Dear East Bellevue Community Council Chair Hummer,

Thank you for reaching out to PSE's Energize Eastside team with questions posed by East Bellevue Community Council members and meeting attendees. The attached document includes our responses, which often reference the [Cities' Final Environmental Impact Statement](#) that was issued on March 1, 2018.

Figure 1-1. PSE 230 kV Transmission System in the Eastside

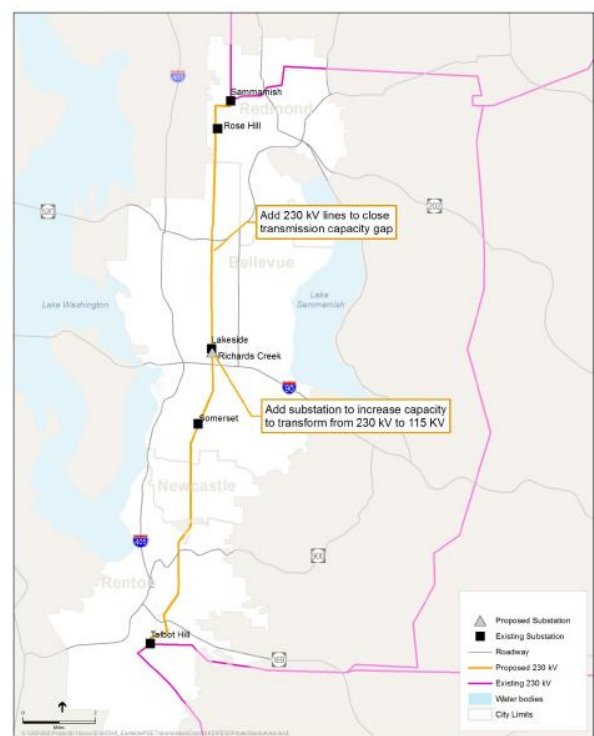
Q: “Where does this energy supply go – West Bellevue, Bel-Red, Downtown?”

Energize Eastside will deliver reliable power to businesses, residences and municipal uses in the Eastside, from Redmond to Renton. See map to the right from the Partner Cities’ Final EIS (page 1-2).
